### ADDENDUM NO. 2

ALBANY ELEMENTARY BUILDING ADDITION & RENOVATION PROJECT 700 W. STATE ST. ALBANY, IN 47320

OMS PROJECT NO. 22063

MARCH 25, 2023

END OF ADDENDUM NO. 2

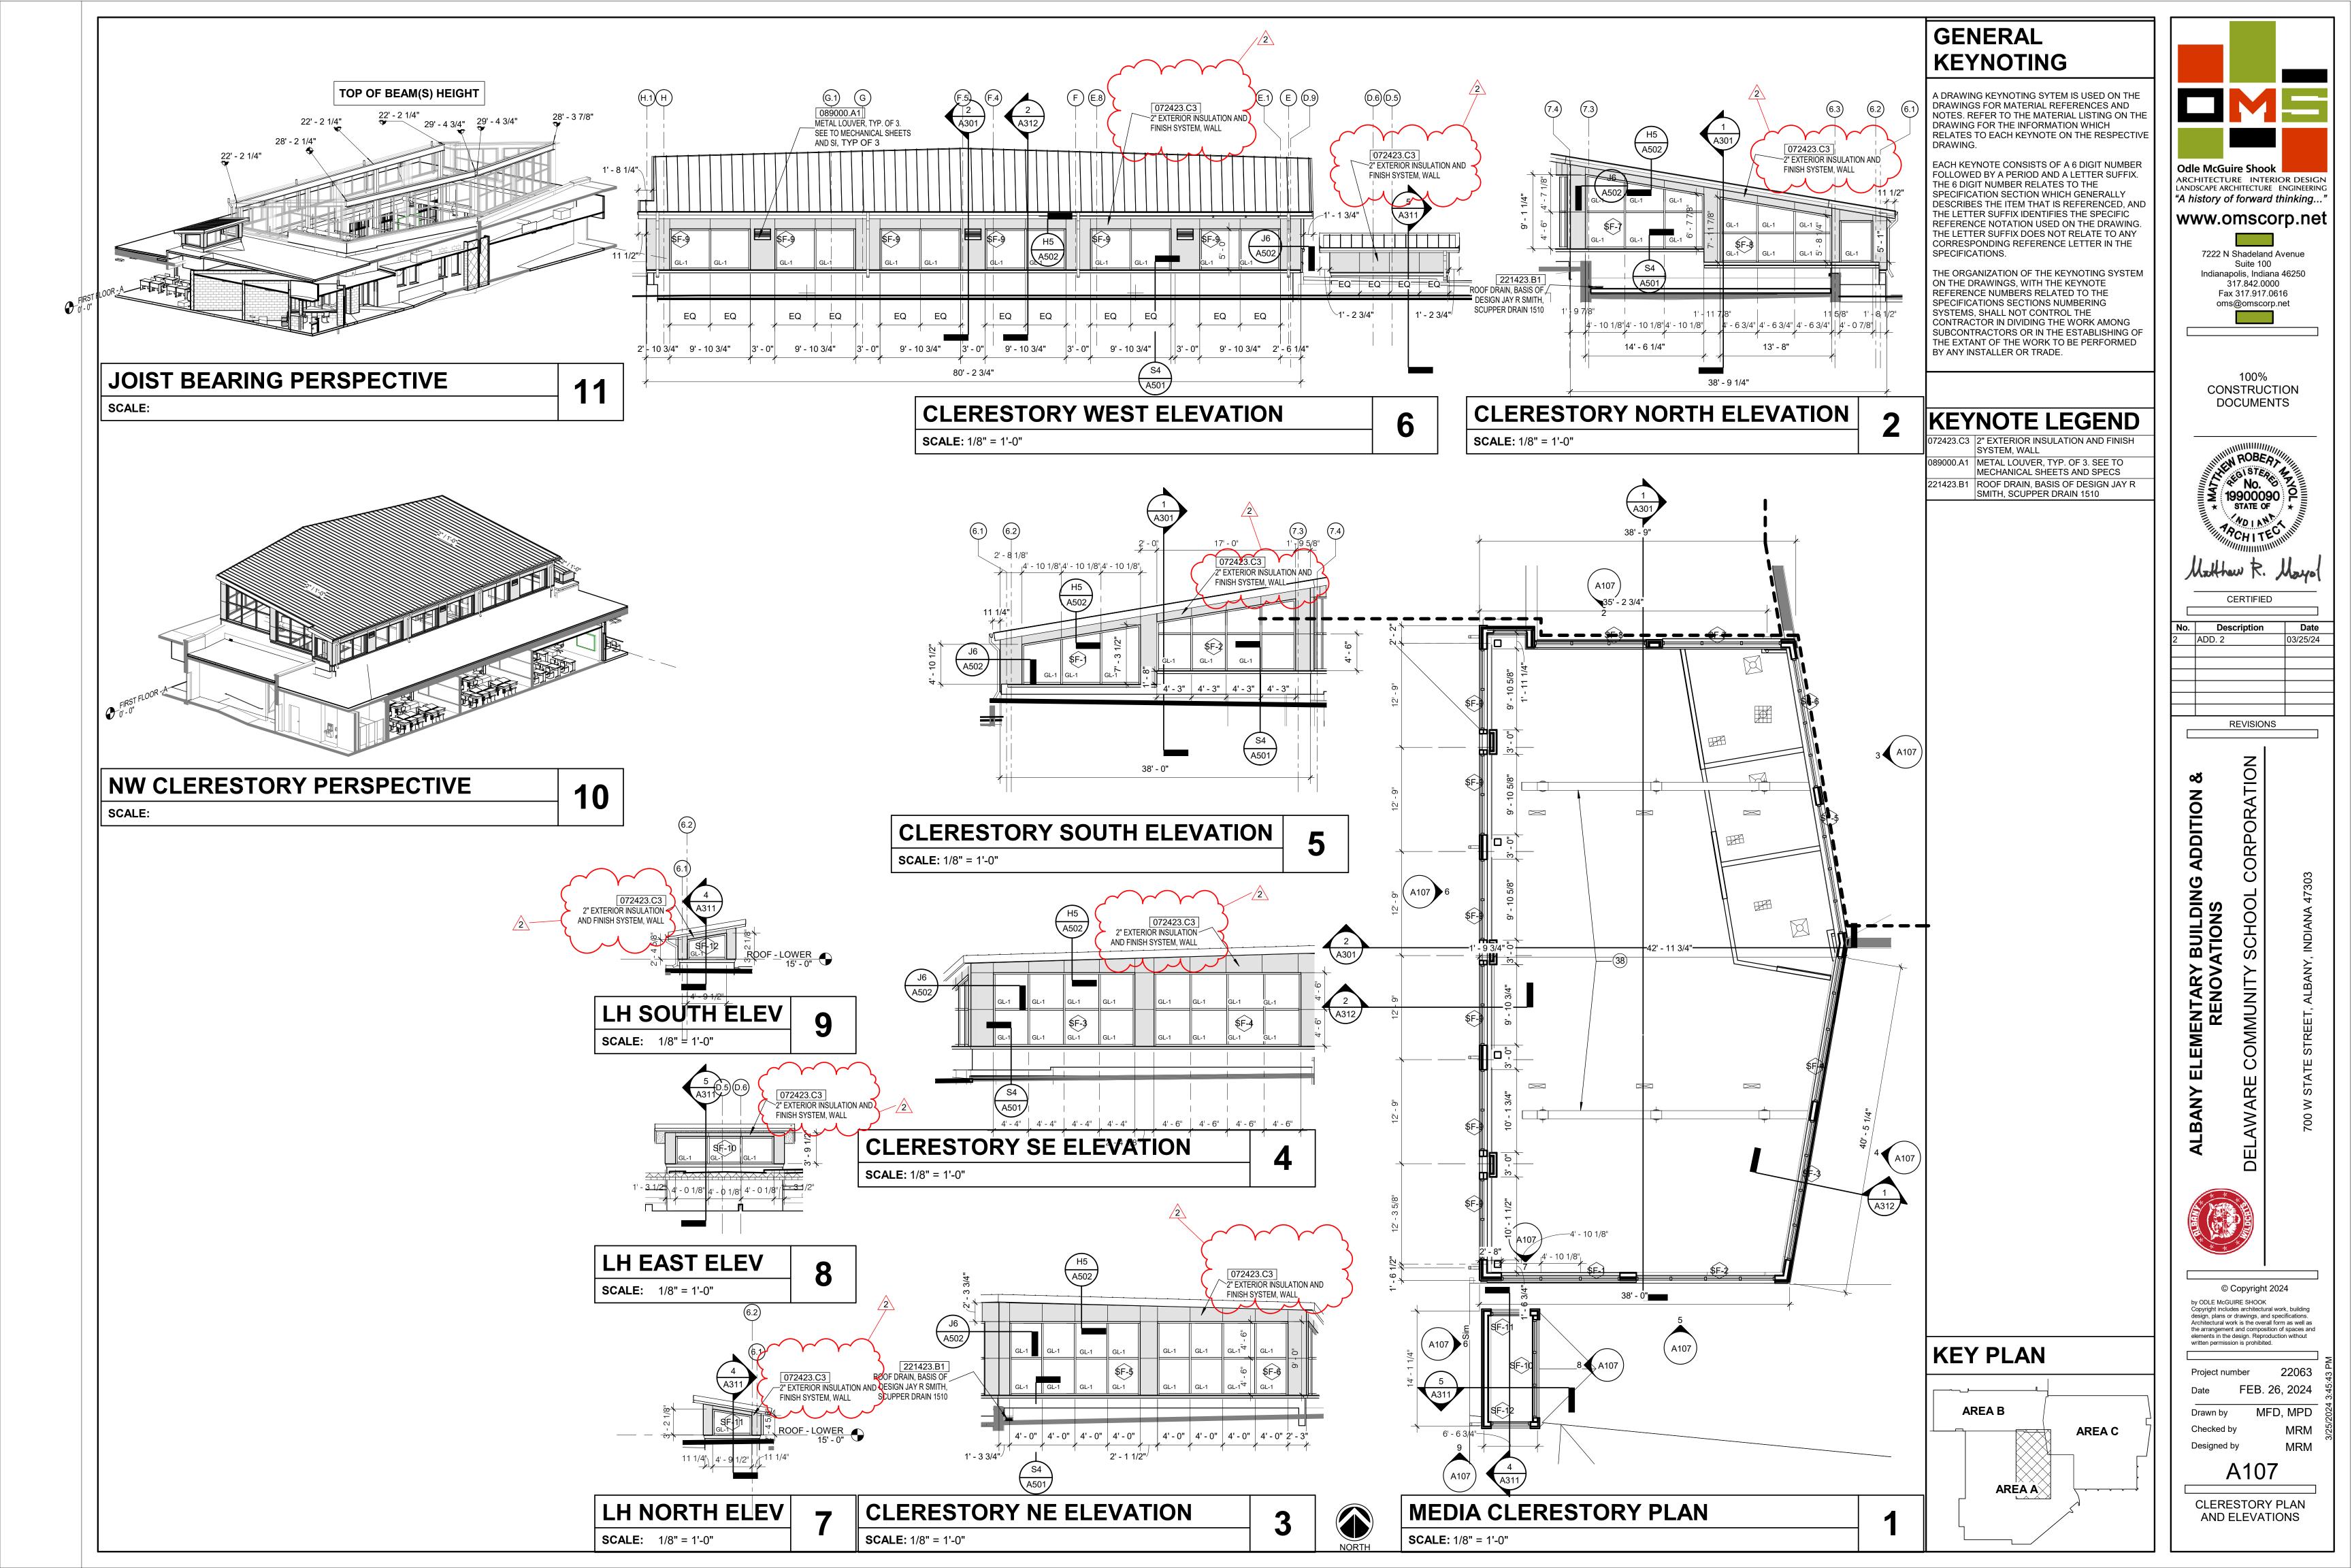
- 2. Drawing A311 WALL SECTIONS
  - A. Detail 4 revise Keynote to 072423.C3 2" Exterior Insulation and Finish System in lieu of 074213.A1 Aluminum Composite Panel.
- 3. Drawing A501 OPENING SCHEDULES & DETAILS
  - B. Detail S4 Revise Keynote to 072423.C3 2" Exterior Insulation and Finish System in lieu of 074120.A1 2" Insulated Metal Wall Panel.
- 4. Drawing A502 OPENING DETAILS & ELEVATIONS
  - C. Details H5 & J6 revise Keynote in to 072423.C3 2" Exterior Insulation and Finish System in lieu of 074120.A1 2" Insulated Metal Wall Panel.
